AGENDA

Planning and Zoning Board City of St. Augustine, Florida

Tuesday, August 1, 2023, at 1:00 p.m.

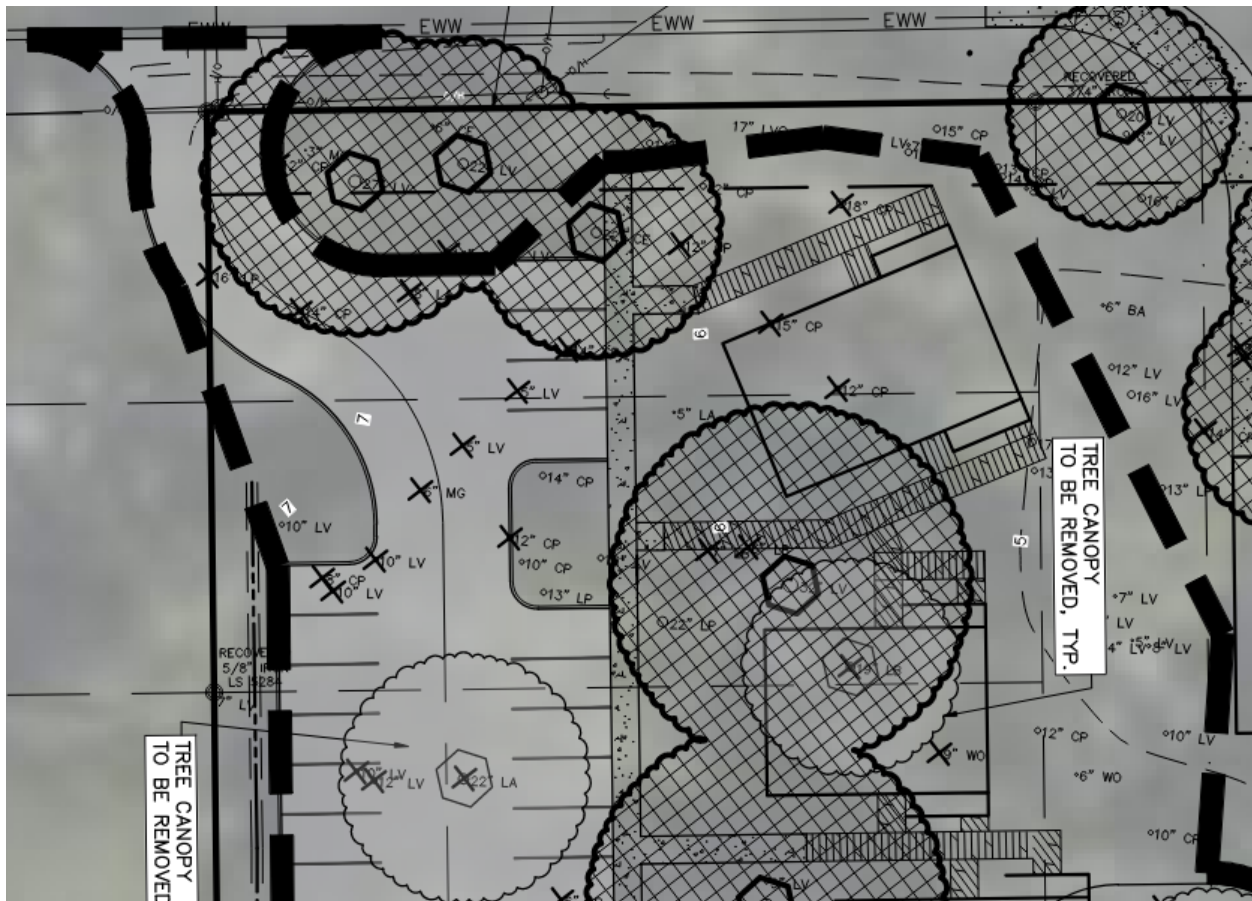
It is staff's understanding that three companies JBPro, Borton Design Inc., and Carter Environmental Services are the three firms associated with this proposal known as EcoVillage. Below are examples of differences in proposed development plans that are of concern to staff.

Figure 1. This screenshot of the area of the property adjacent to Julia Street is from the submitted Tree Canopy Exhibit produced by JBPro. In the landscaped area close to the center of the photograph it is shown that three Cabbage Palms are to remain and one to be removed. This is contradicted by the plans produced by Borton Design Inc. which may be found in Figure 2. In the vicinity of the northern most stairwell there are two palm trees of 12 and 18 inches shown to be removed, in the plans from JBPro only one is proposed for removal.

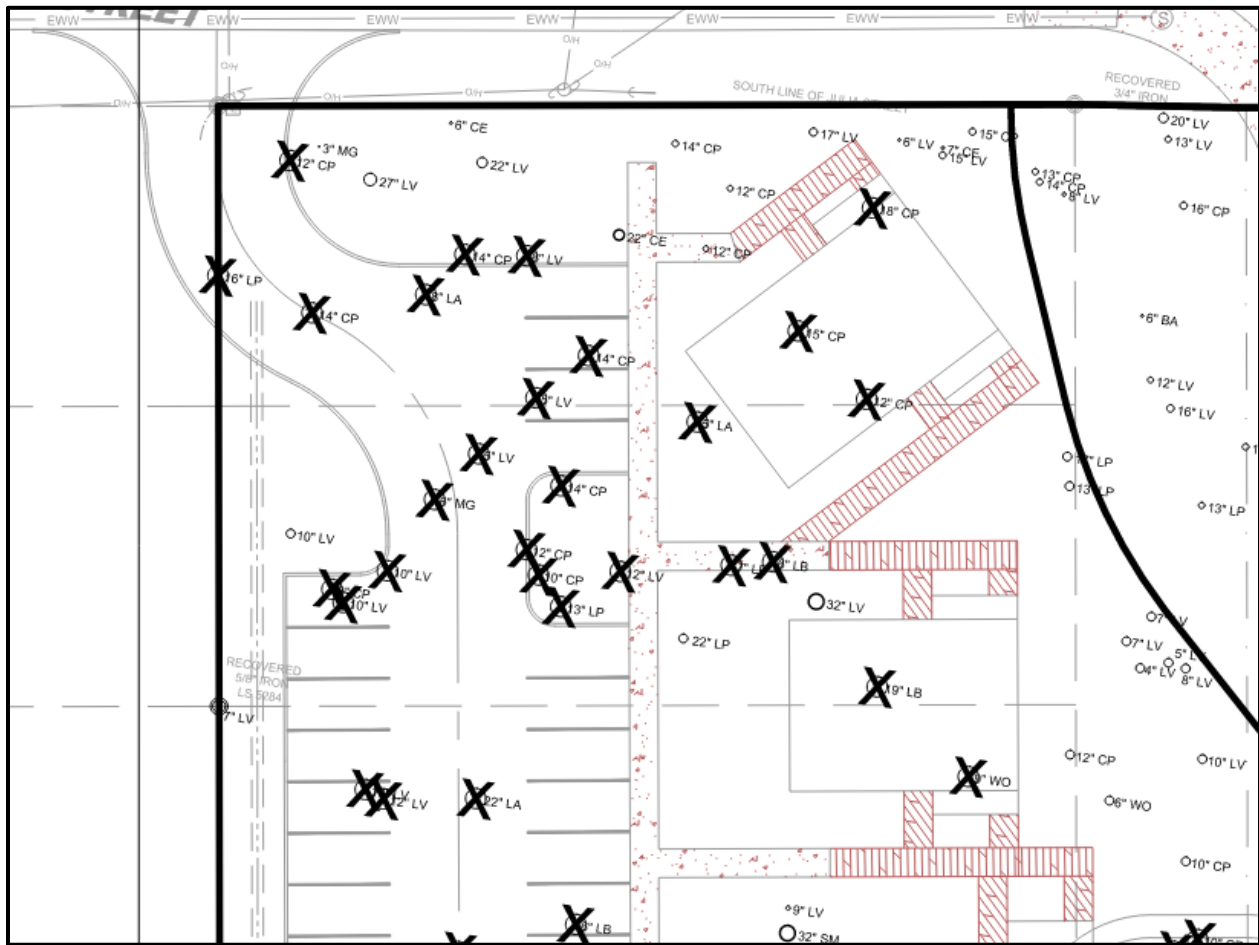
Figure 2. This screenshot is from the Tree Removal Plan supplied by Barton Design Inc. and shows the same area of the property as in Figure 1. The previously mentioned landscaping area within the parking lot, located in the center of the photograph, shows removal of all trees. The previously mentioned palm trees located in the vicinity of the northern most stairwell a 12" palm is shown to remain, even though it is located in the middle of a sidewalk.

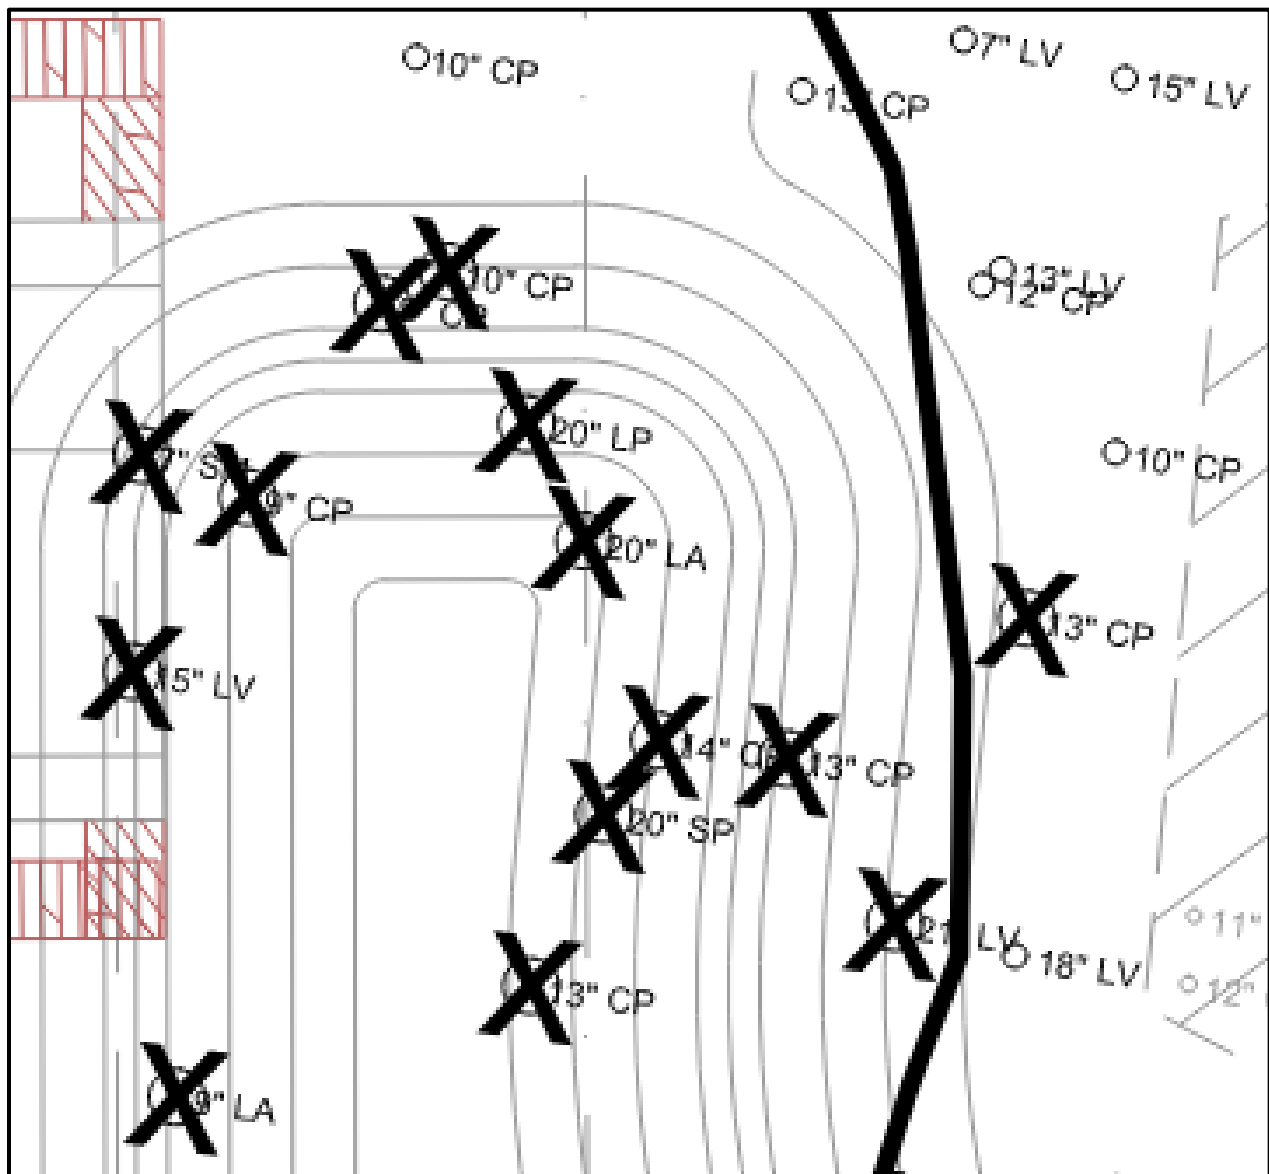
Figure 4. This is a screenshot from the Barton Design Inc. Tree Removal plan showing the northern edge of the stormwater retention area. In the bottom right corner of the photograph an 18" Live Oak, a significant tree as defined in Sec. 11 of the City's Code of Ordinances, is shown to remain even though JBPro plans call for its removal.

Figure 10. This screenshot from the JBPro Tree Canopy Exhibit shows the proposed townhome development. The rationale for the proposed removal of two 13" Cabbage Palms, bottom left corner, a 13" Cabbage Palm, top middle, and a 4" Pecan tree, top middle, is not clear.

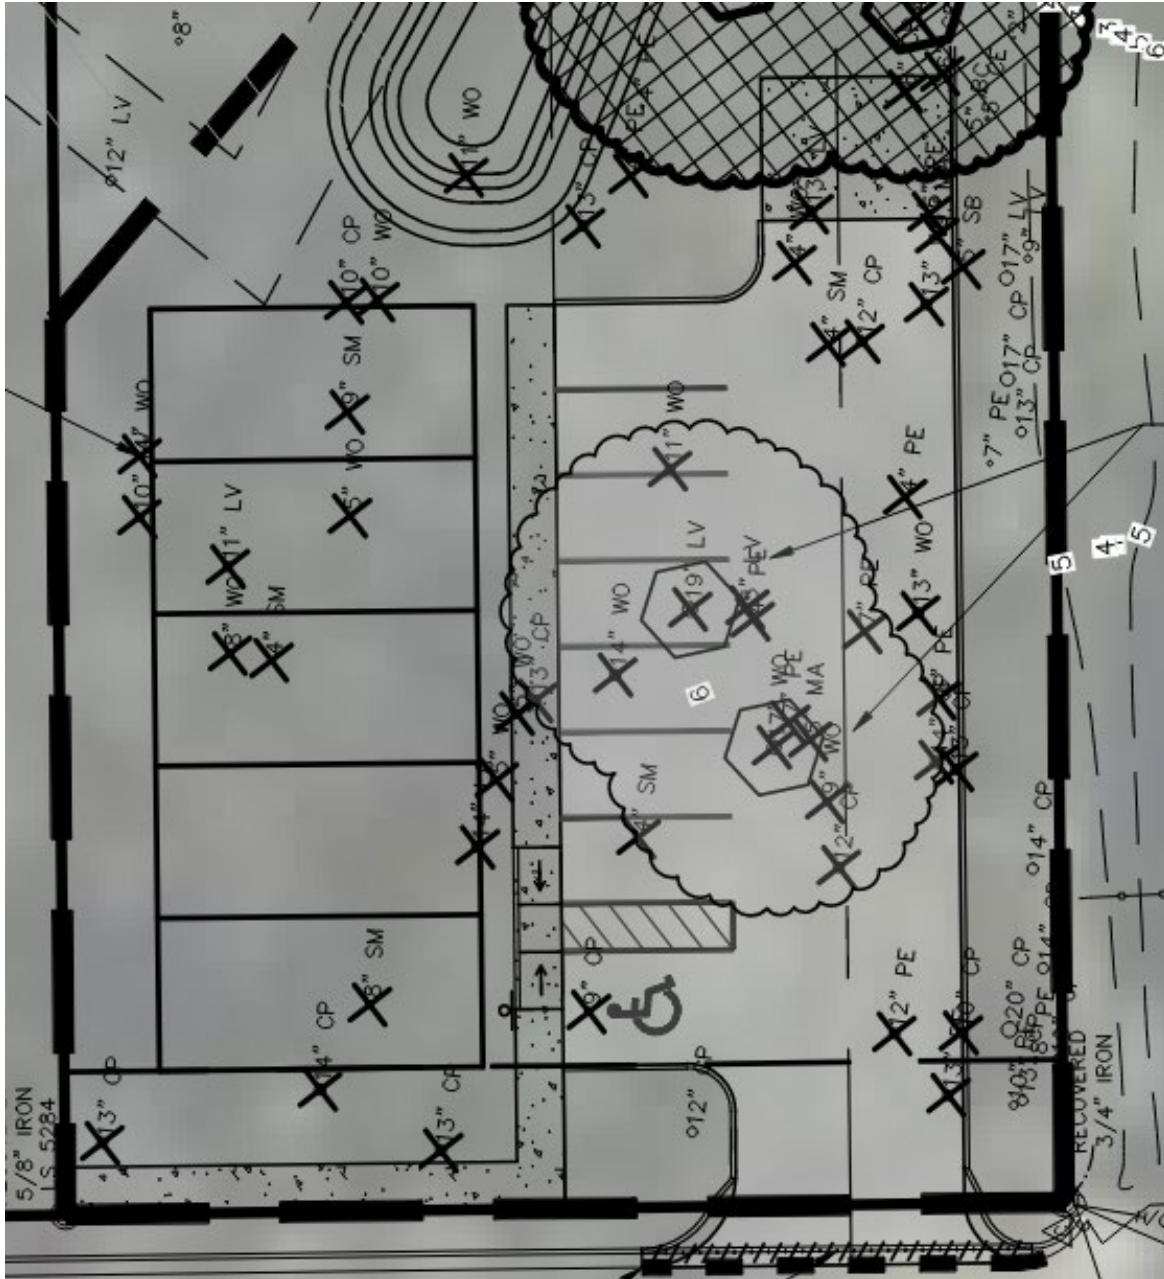
Figures 10 and 11 below illustrates a question regarding the need to remove the indicated trees.
